Big Eddy-Knight Transmission Project

Final Environmental Impact Statement

Volume 3: Comments and Responses

DOE/EIS-0421

- 1. Photo of existing 115-kV transmission line poles near Kissler property in Klickitat County, Wash. (Comment #BEKD10061)**

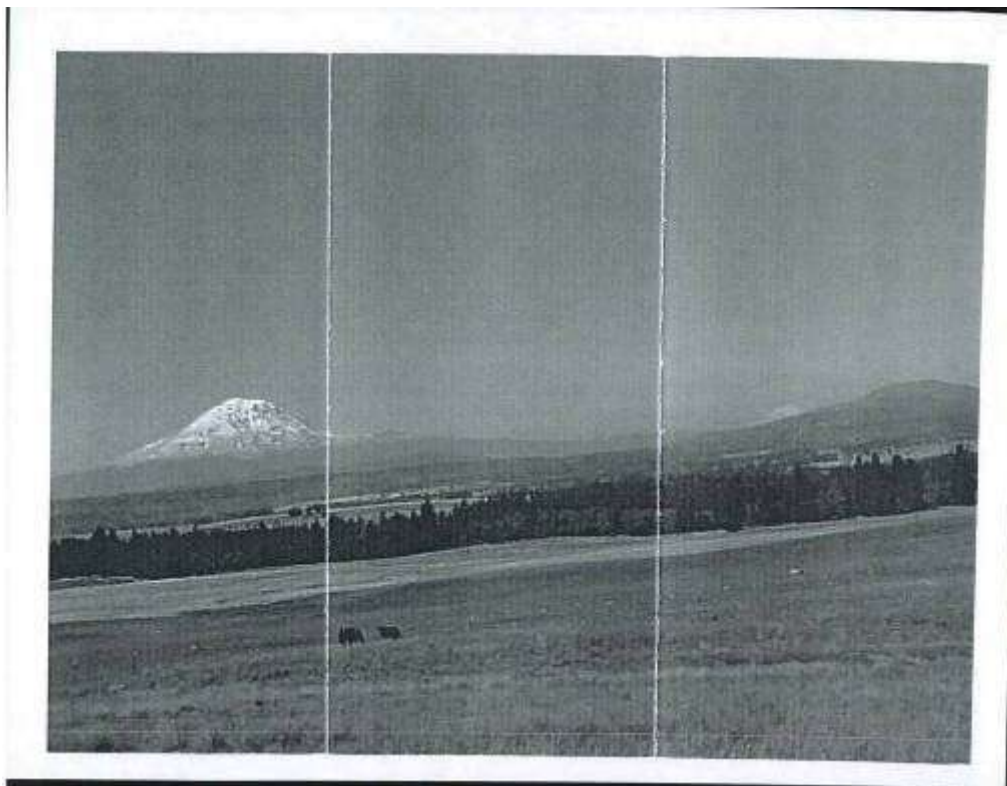
10011-004 I will forward supporting exhibits of my concerns on the Western Alternative visual impacts located between line mile w-18 and w-19. I simply have used maximum existing pole height and compare it with maximum single and double circuit pole heights. Figure 3-5 showing existing view versus simulated view in the EIS is not representative of the visual impacts on our development. Please make this e-mail a permanent part of the public record. Let me know if you have questions or need clarification on my statement or exhibits and please reply you have received this e-mail. Thanks.

10060-001 Thank you for the exhibits. They are part of the public record.
